FINAL DRAINAGE REPORT

LOT 1, OWL MARKETPLACE FILING NO. 1

MURPHY OIL #7968
7440 MERIDIAN PARK DRIVE
FALCON, CO 80831

PCD File No. XXXXX

PROPOSED DRAINAGE MAP

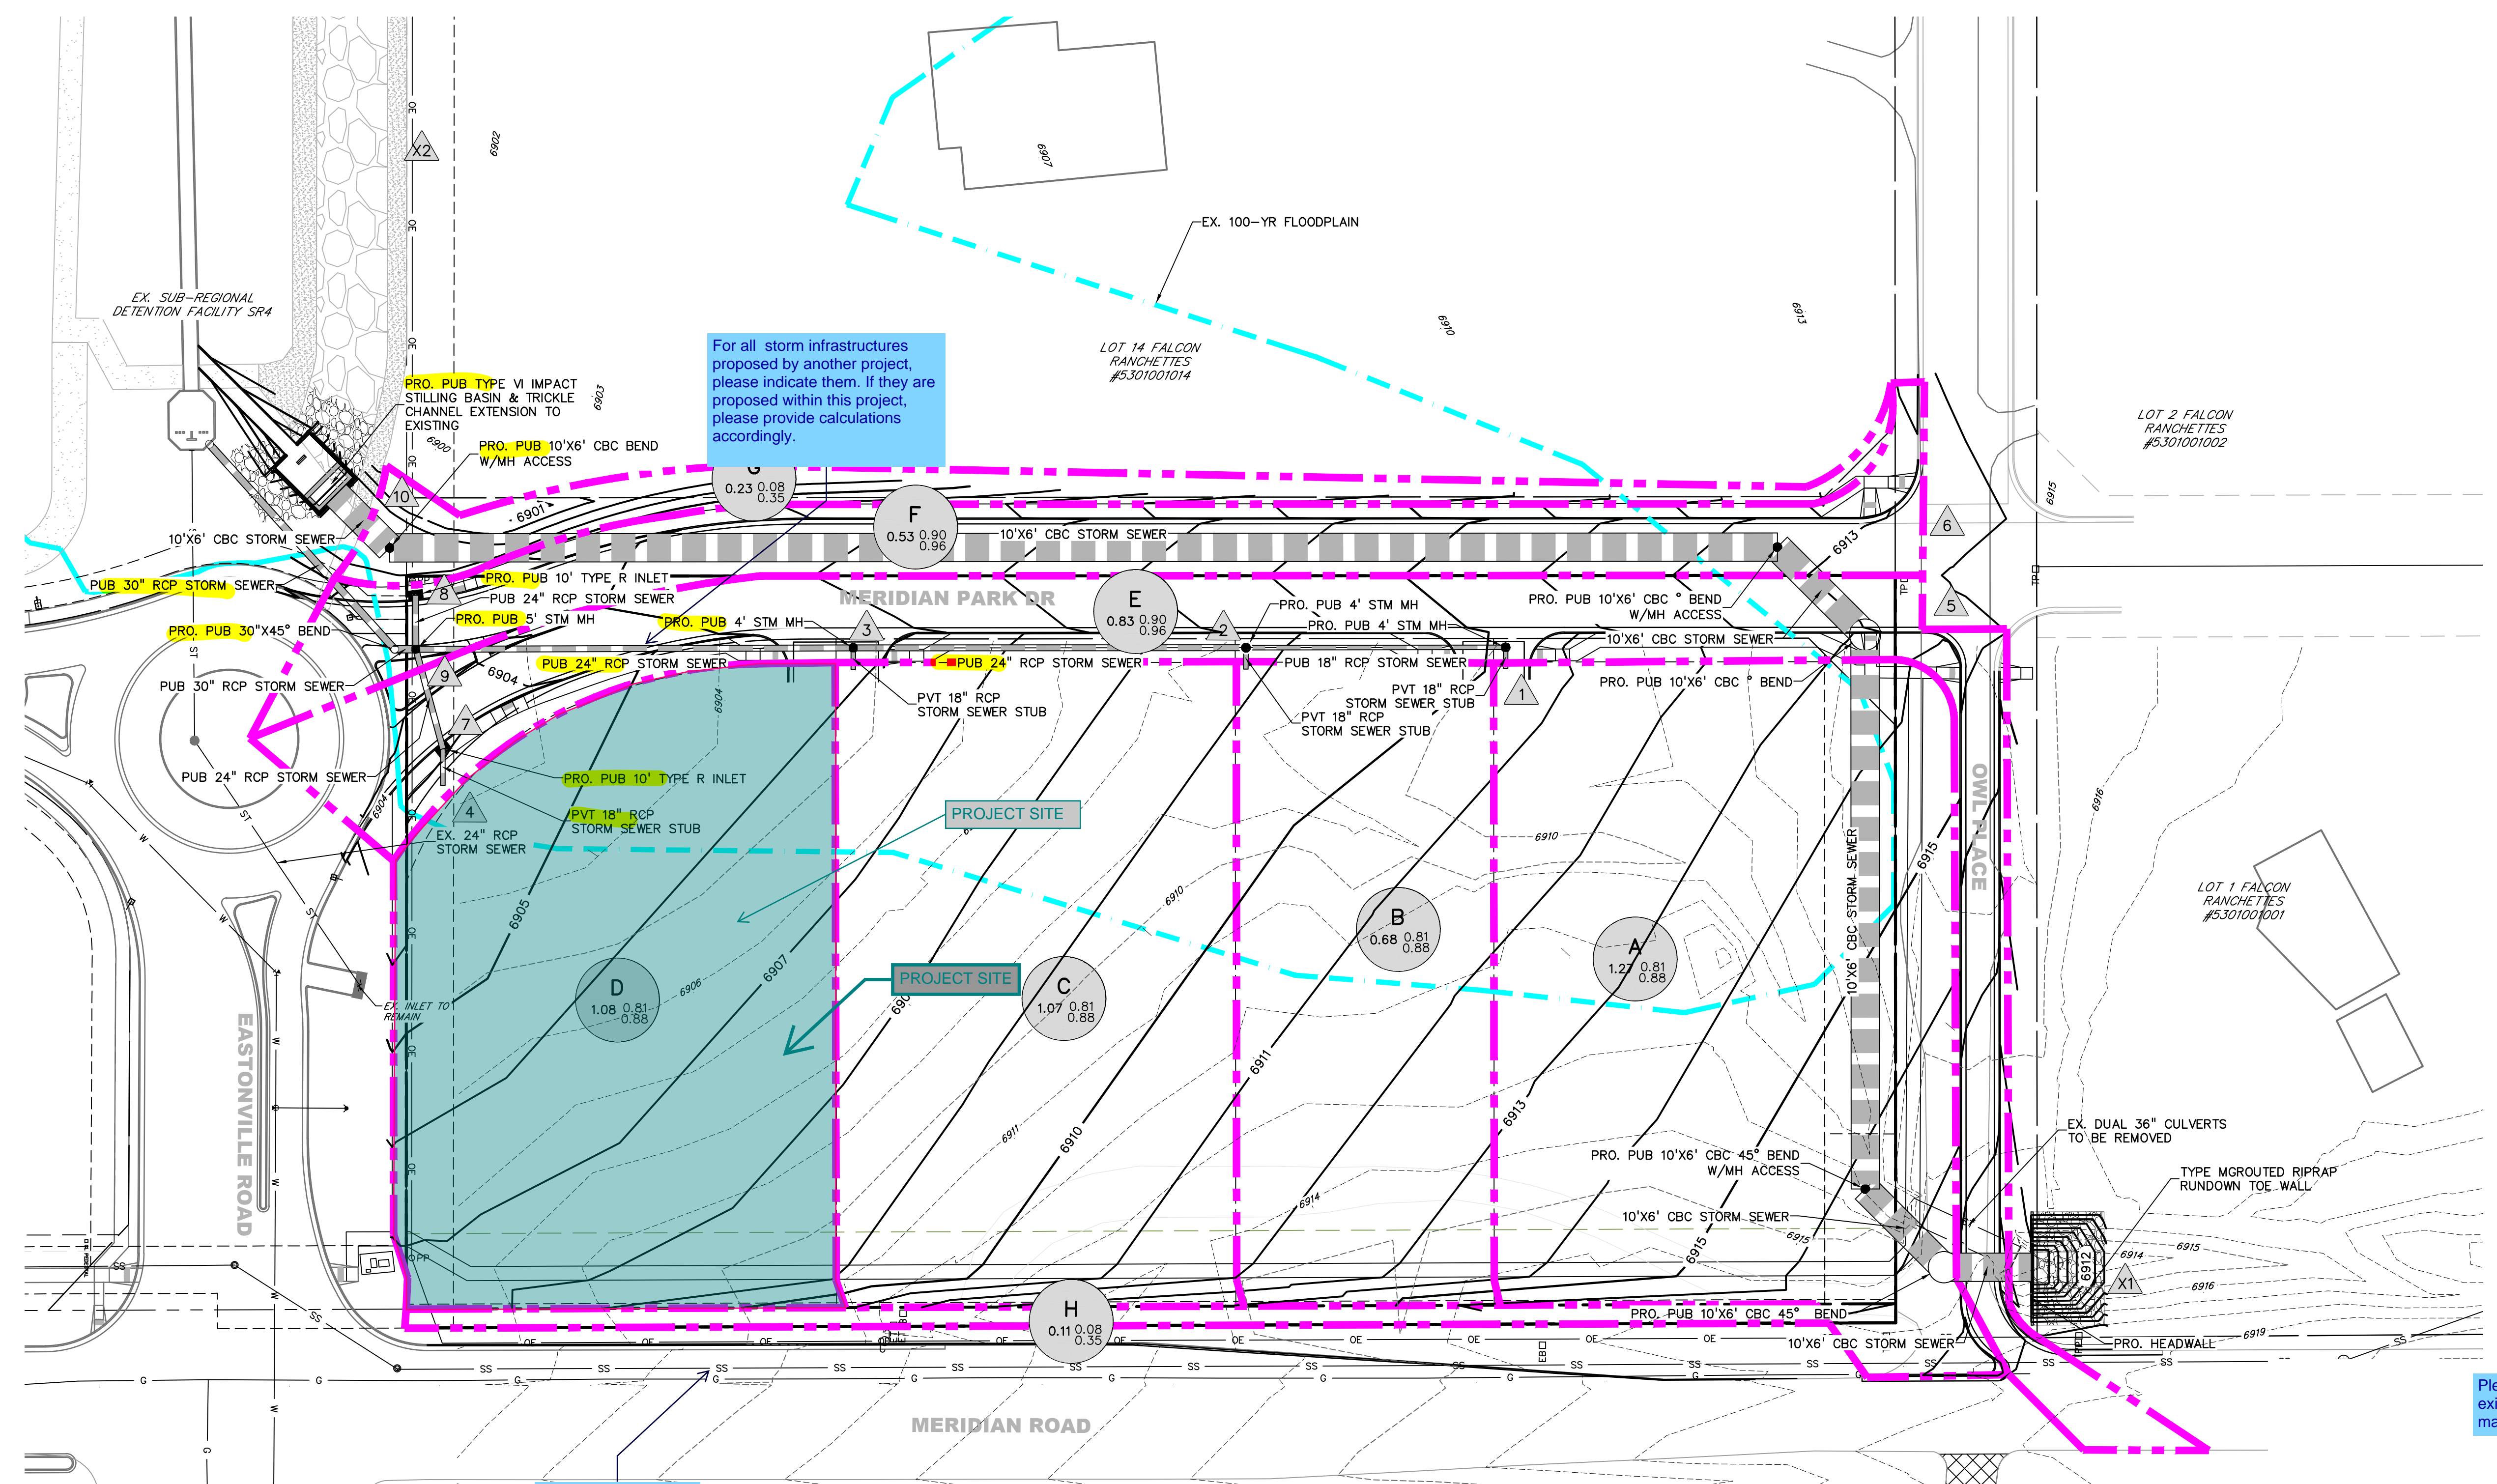
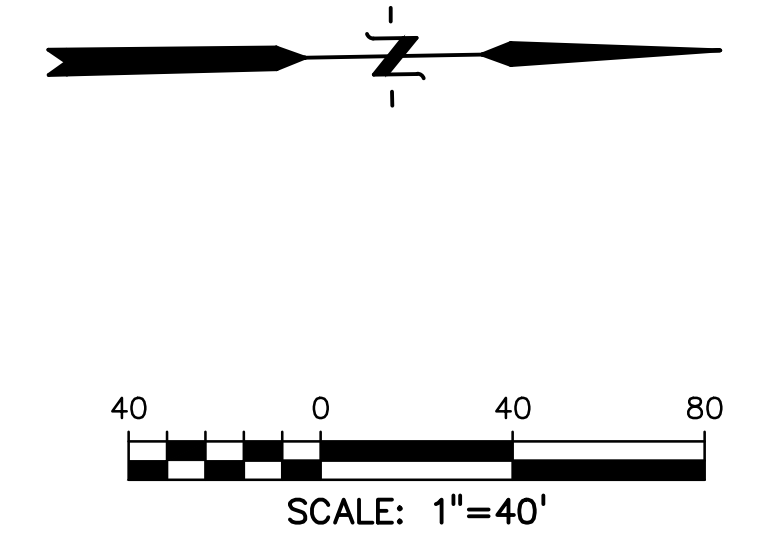
Please add flow direction to the existing map.

Please revise it to be existing drainage map.

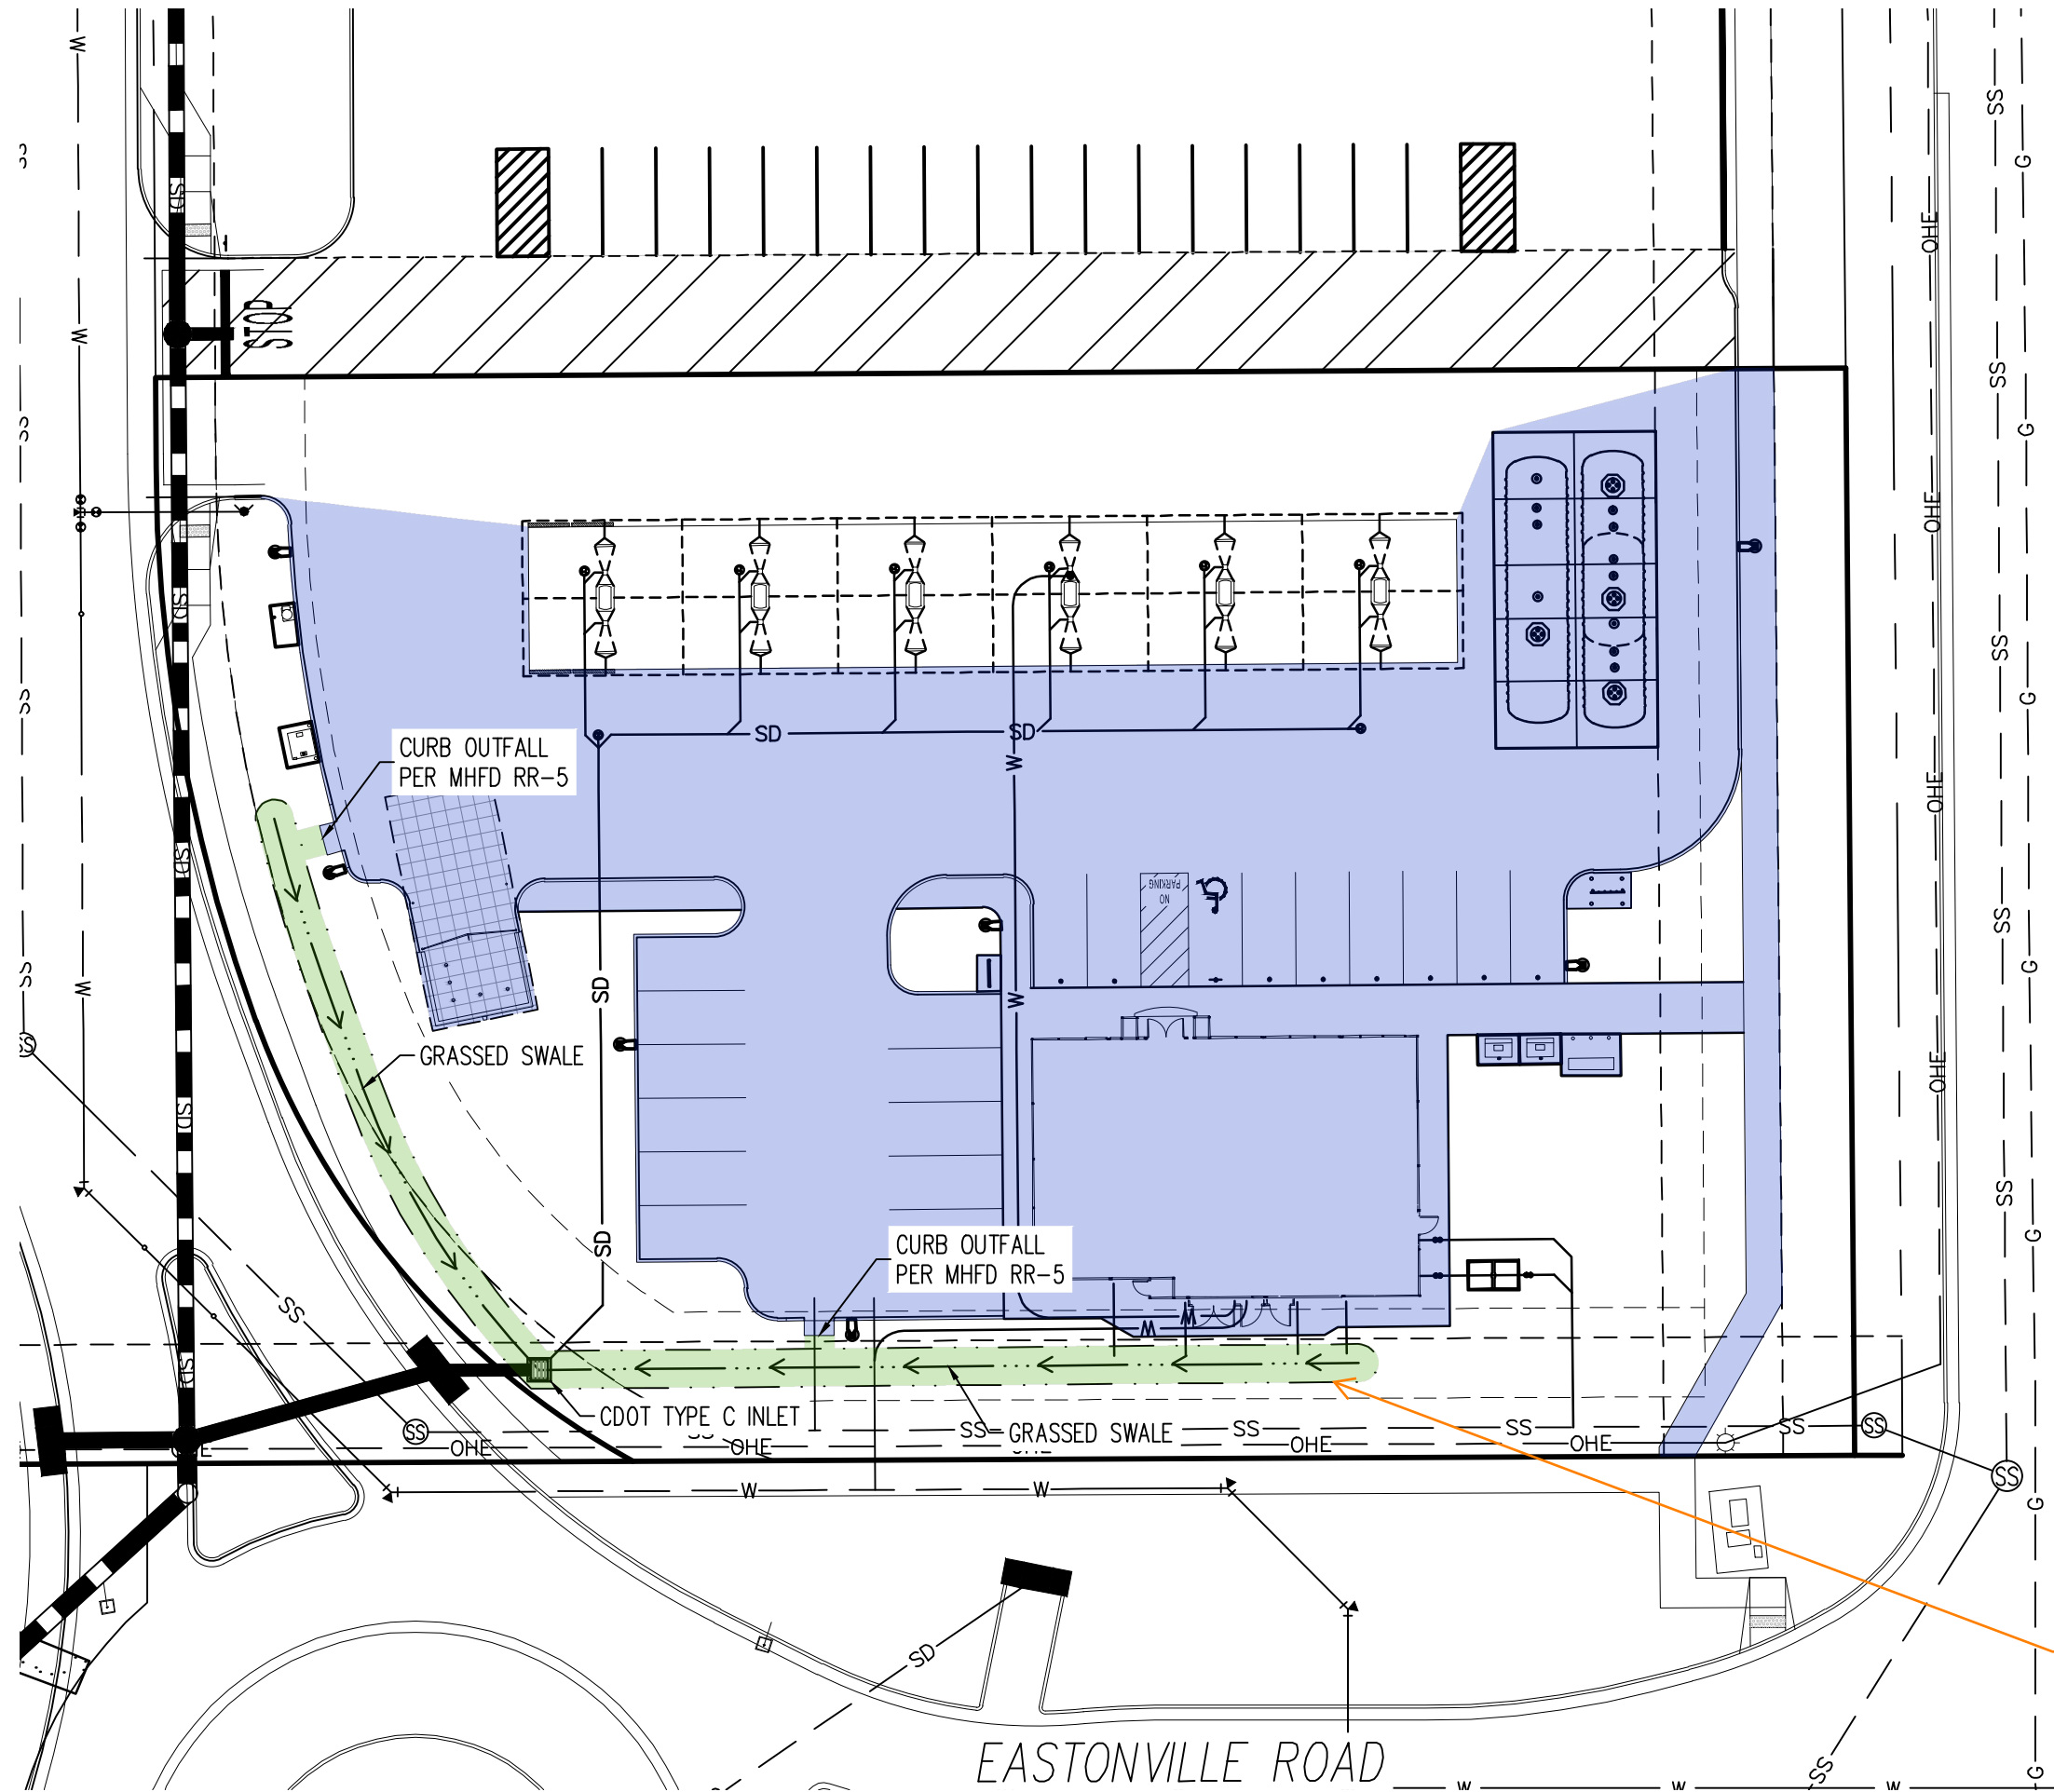
These swales cannot be considered RPA's if they are to be rock cobble as specified in the Landscape Plan. Cobble is comprable to 80% impervious gravel on Table 6-6 of the DCMv1 Chapter 6 update. And therefore is not very pervious.
